Brooklyn connections

All submitters feedback

27 June - 23 July 2023

Upper Brooklyn Road above Bidwill

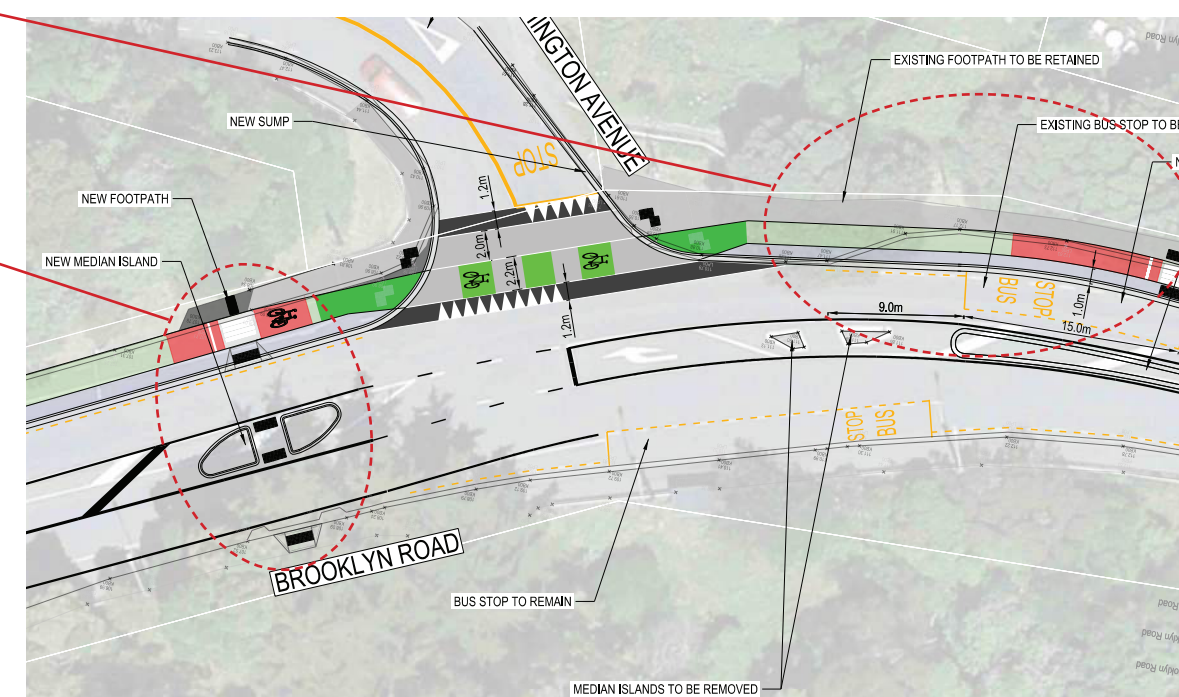
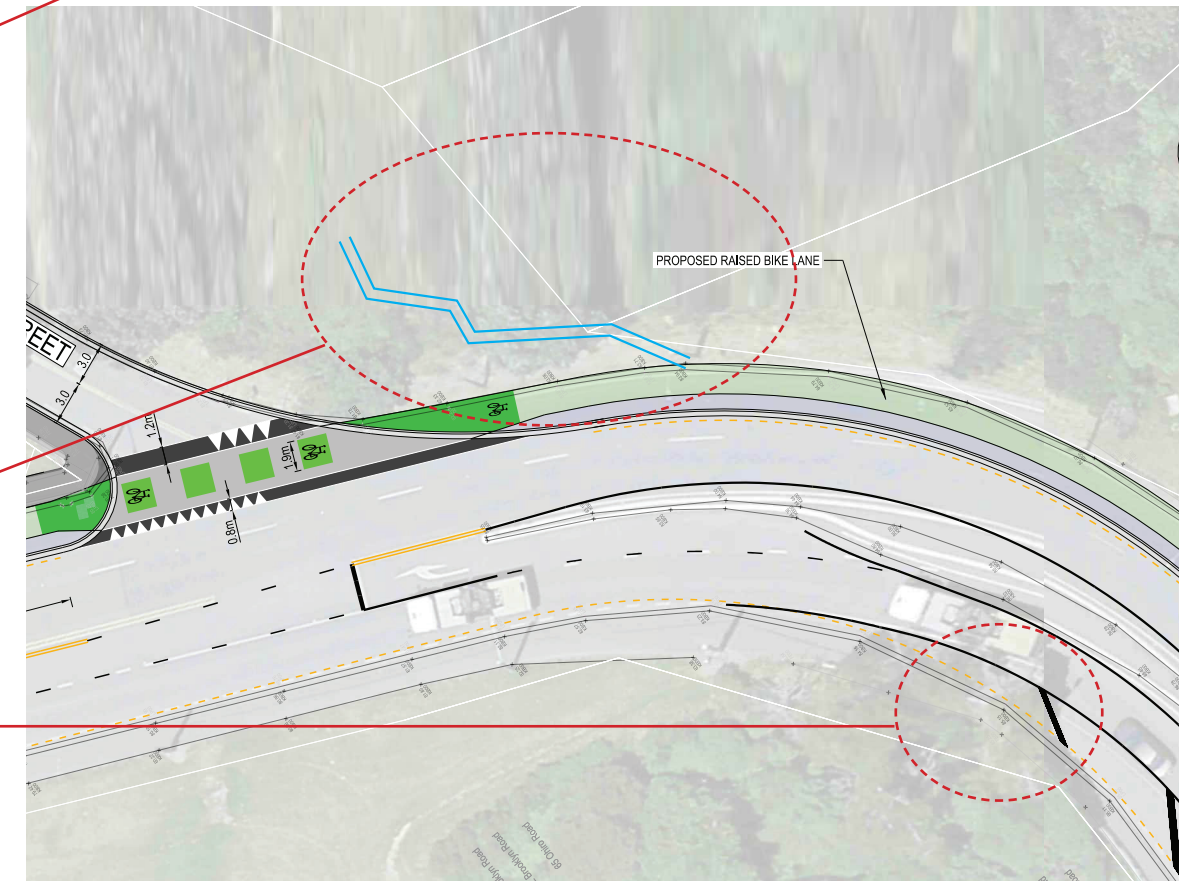
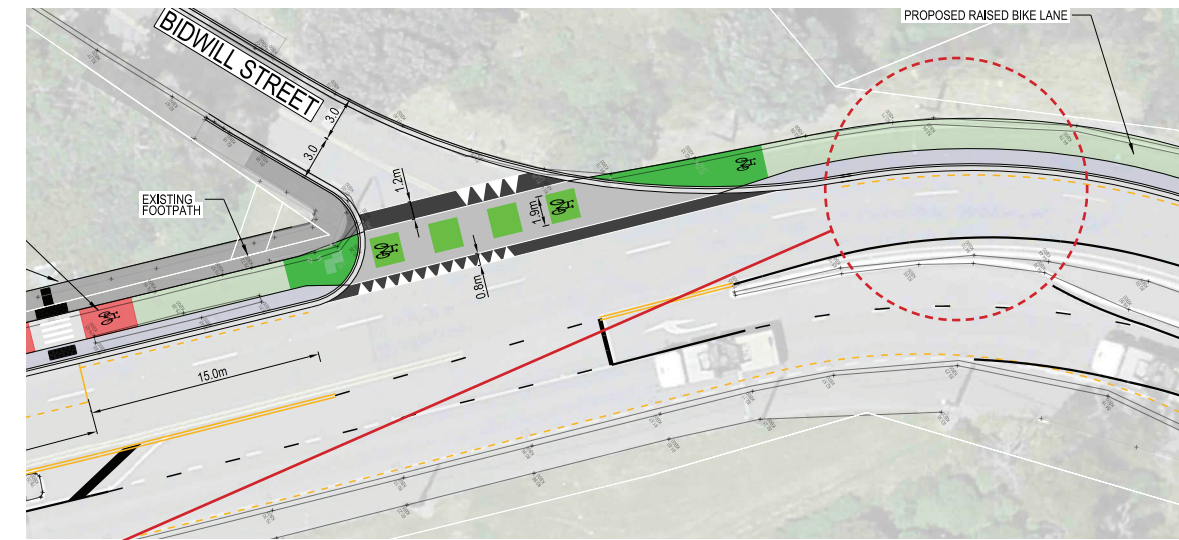
8. The project should provide a walking route down the uphill side of Brooklyn Road between Washington and Bidwill. This is a great opportunity to provide a more direct route for those walking via Bidwill to Wellington High, Wellington College, Wellington East secondary schools, Massey University, and into Te Aro. Many of these students currently follow the 'desire line' using the median island at Rogers Corner and will be more inclined to do so when the authorized refuge crossing is moved further down Brooklyn Road. I understand this pedestrian route was considered as an option and rejected due to the cost. However the current drawings show a 1.5m wide zone between the cycle and vehicle lanes which could function as a narrow footpath for those keen to use this side of Brooklyn Road. As cyclists are moving uphill there is less risk of pedestrians and bikes colliding. Also, if this strip was moved to the bank side it would help distance the bikes from dirt and rocks that spill off the bank and give pedestrians more distance from moving vehicles.

9. In addition to recognizing that pedestrians will walk on the uphill lane side regardless of what's built, a set of timber steps between Rogers Corner and Bell Road would provide a direct route that would avoid pedestrians having to lose height by dropping to the Brooklyn/Bidwill intersection and then back up to the Bidwill/Bell Road intersection. This would avoid the tight steep bank on the downhill/south side of Bidwill where it meets Brooklyn Road. This should also be reviewed alongside what Wellington Water's long-term plans are for the Bell Road Reservoir as one option was for a direct vehicle connection at Rogers Corners to avoid the tight Bell Road route for trucks. Anticipating that may help make the steps solution more viable.

Ohiro Road - Brooklyn Road to Todman

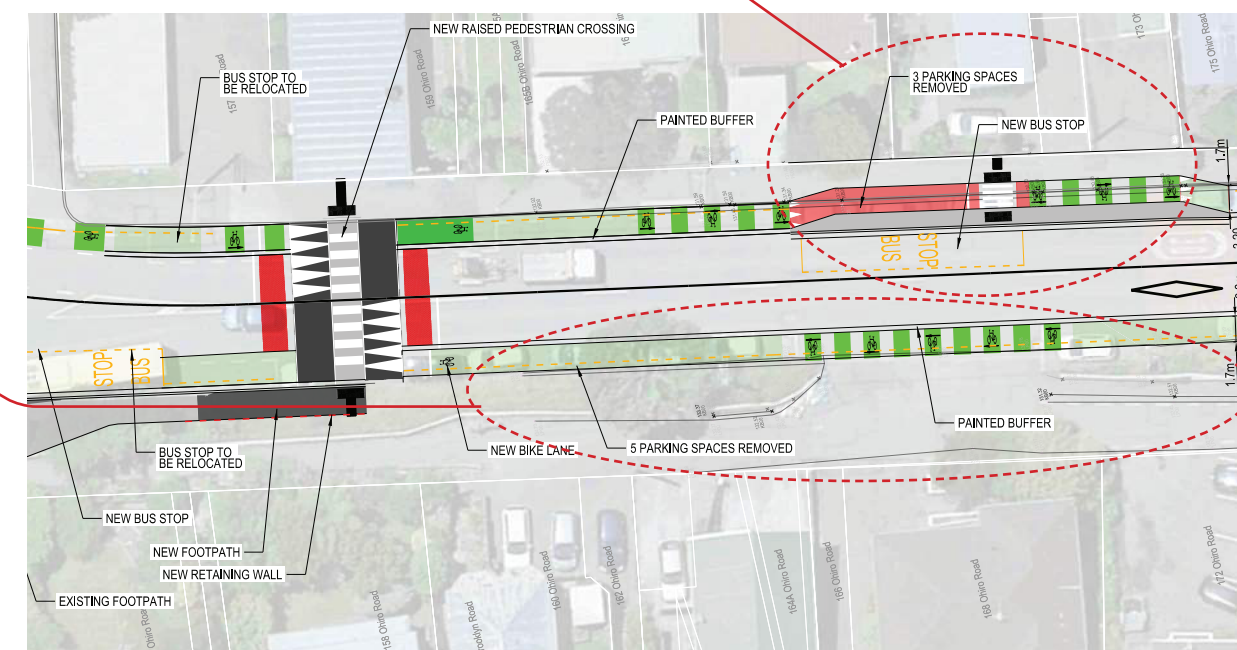
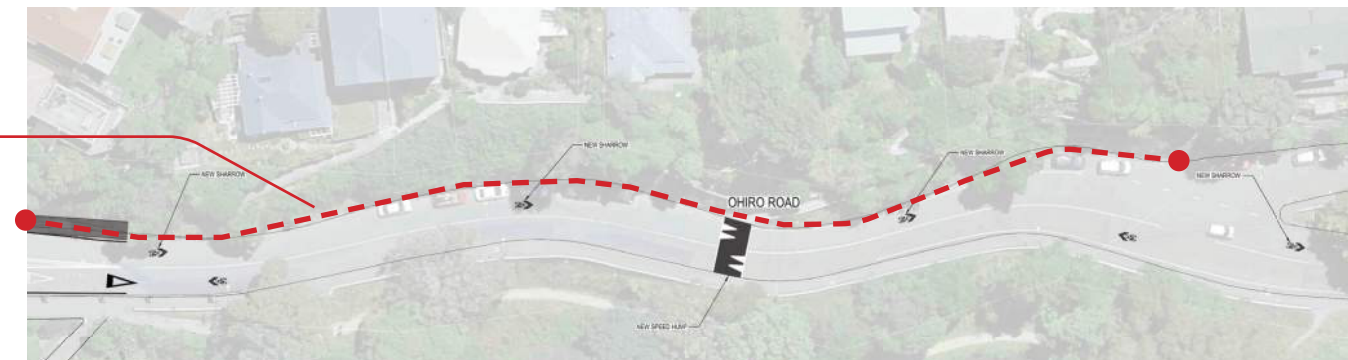
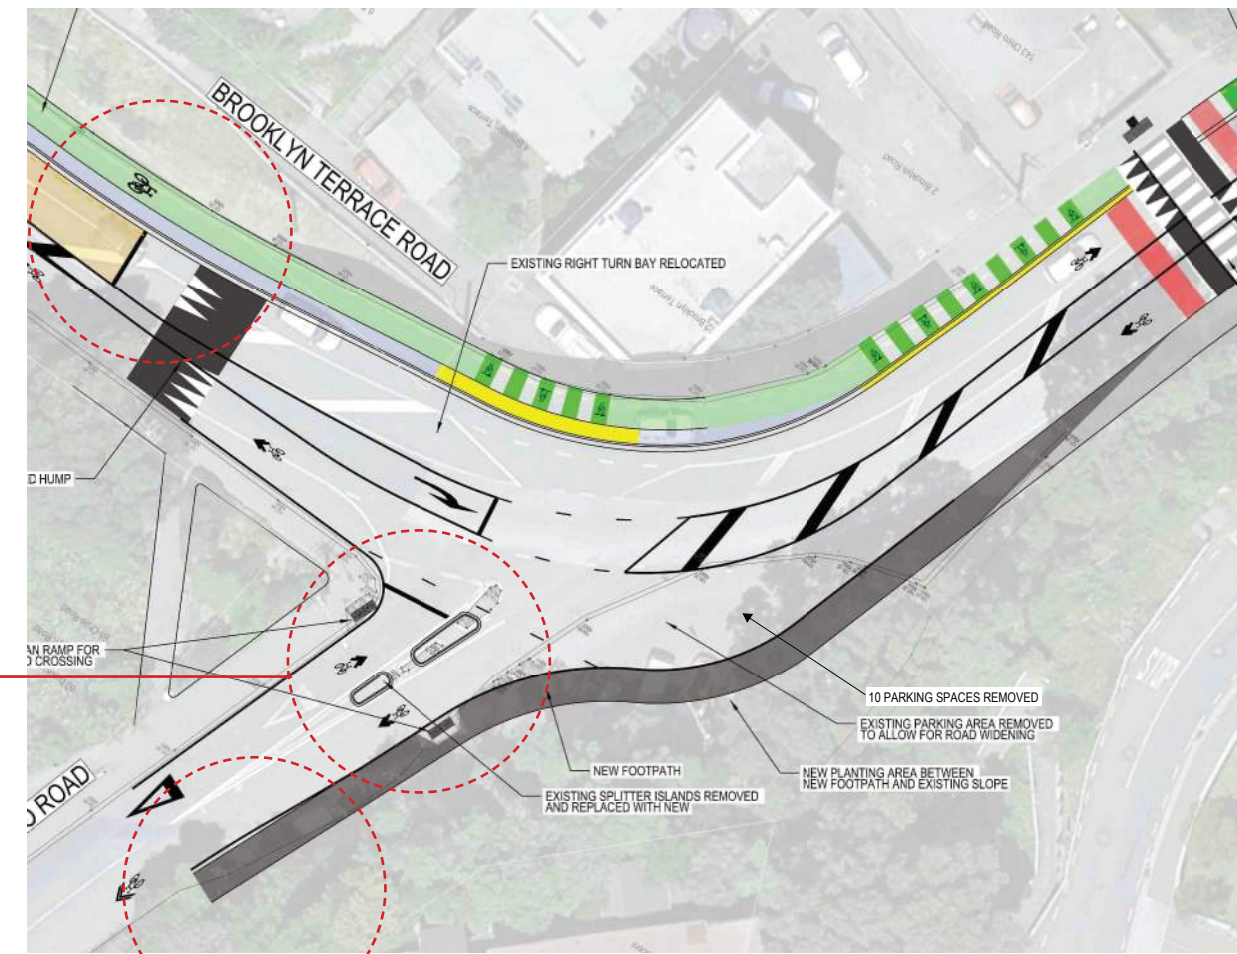
13. The proposal to make improvements to the Brooklyn/Ohiro intersection for the safety of all users, but particularly the most vulnerable who are walking and cycling is great! I do think the crossing just below the intersection of Brooklyn and Ohiro not being a proper pedestrian crossing is a shame as that will be the only uncontrolled main crossing on the route between Brooklyn and the CBD... however I do understand the explanation that vehicles turning right down into Ohiro Road won't have a safe opportunity to align giving way to both the downhill traffic and pedestrians on a zebra crossing who have the right of way. I realize this will come in the Detailed Design phase but the current concept drawings do not give the impression of slowing down the Ohiro Road traffic enough. From my observations many drivers do not indicate or feel they need to slow down and hence for pedestrians crossing Ohiro Road here there is a decent amount of goodwill and luck in deciding to step out.

14. As a resident of 132 Ohiro Road, one of 5 properties whose access is the first path down Ohiro Road, I would like to see the carparks between the pedestrian ramp and our path retained, even if that means a very narrow footpath linking to our shared path. There will be a reduced number of on-street carparks but it will retain the ability to drop off and pick up nearer our path, particularly as the layby above is proposed to be removed to make space for a safer intersection layout.

Cleveland Street

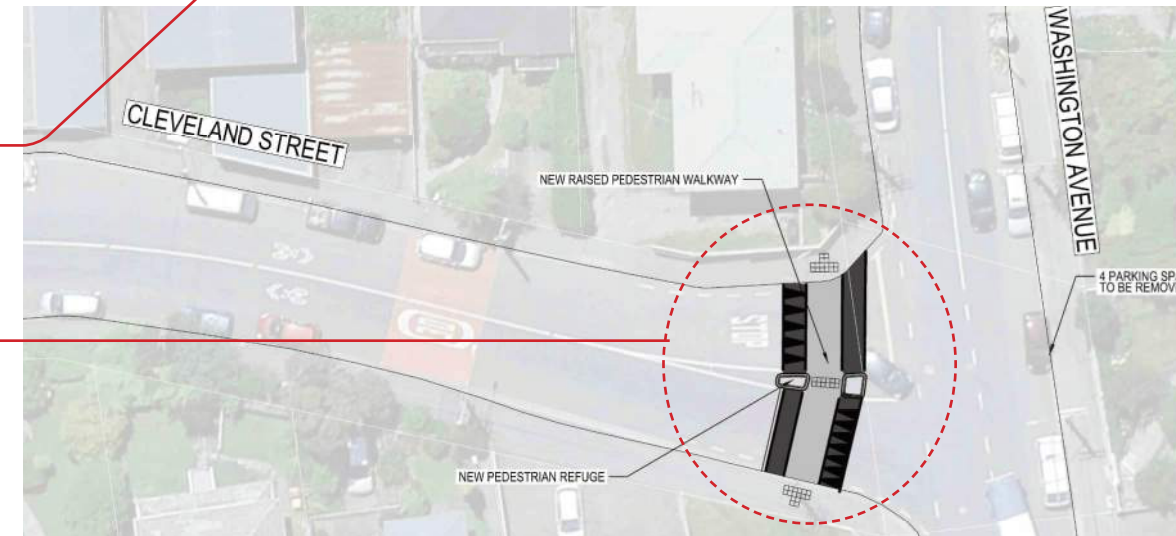
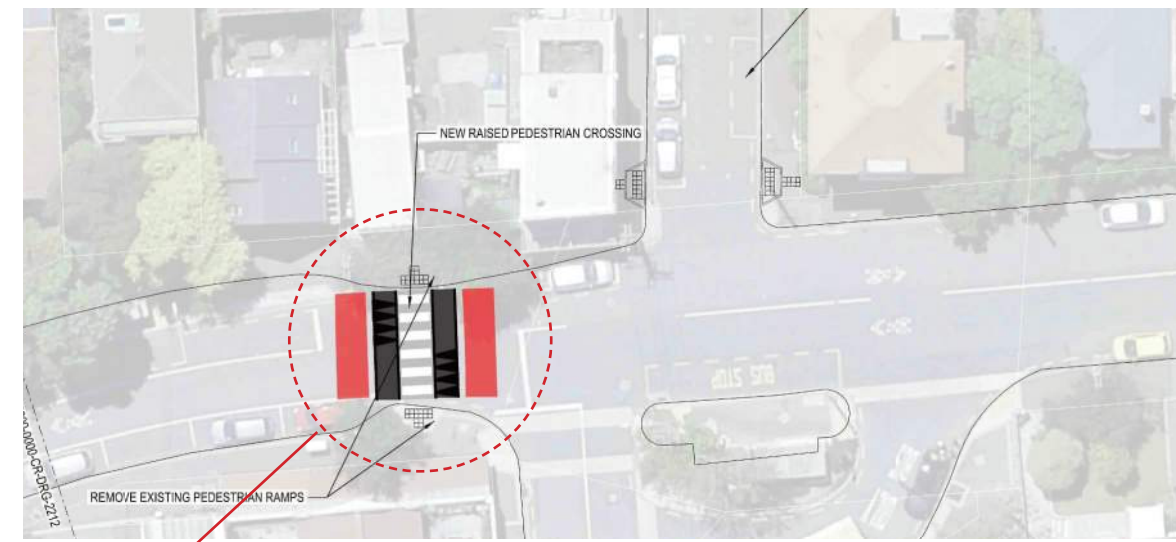
18. I support the introduction of a raised crossing to upgrade the current on grade zebra crossing near the intersection with Jefferson Street. For several years I managed the parent volunteers who monitor and support students walking and cycling to school. The improvements here will make those parent's job safer and help some parents be more willing to let their children walk or bike to school.

19. I support the raised pedestrian walkway across Cleveland at the Washington Ave intersection.

Ohiro Road below Brooklyn Road

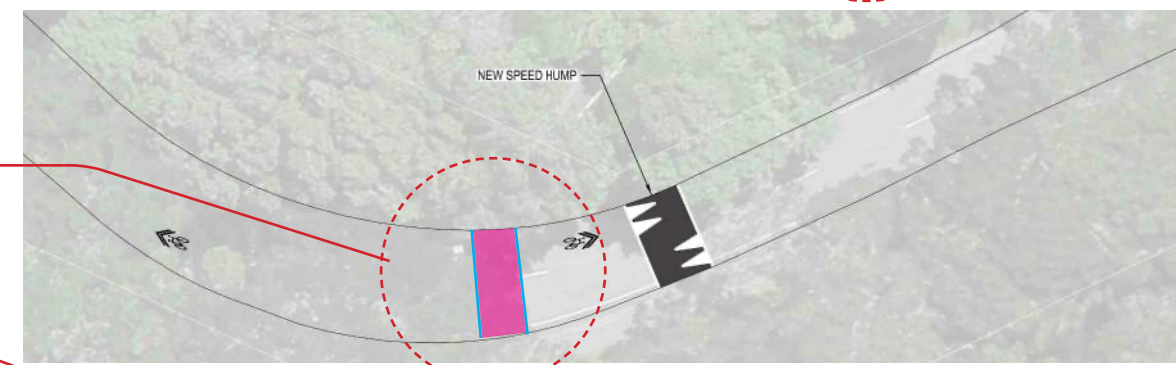
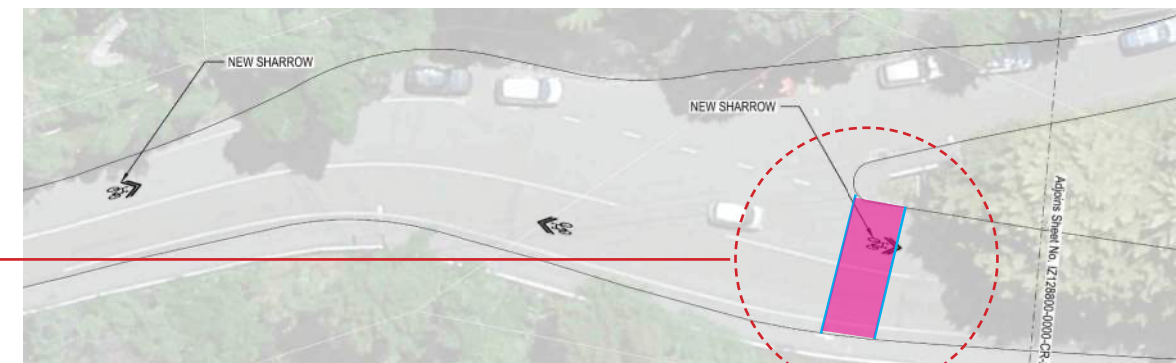
21. I suggest the first speed hump is replicated or moved down to provide a safer pedestrian route across Ohiro to Tanera Cres and down to Tanera Park. This is a well-used route for pedestrians walking to the CBD via Tanera Park and Aro St but also for weekend sport at the old Bowling Club and Tanera Park. All the sport here is for primary school aged children so promoting and enabling them and their families to walk to their games and practices would be a great benefit. Even more so if it enables the children to begin to do so independently.

22. The next speed hump below Tanera on Ohiro could be moved uphill slightly to be more visible for downhill traffic, so they slow down earlier, but also so it can align with the pedestrian path which zig zags down here from the Tanera Park access road.

23. The last speed hump above Aro Street could be moved downhill about 20m so it aligns with the path that connects to Marama Cres. People using that now have no option of remaining on that side of Ohiro Road as there's no footpath there, hence facilitating them crossing more safely would make sense.
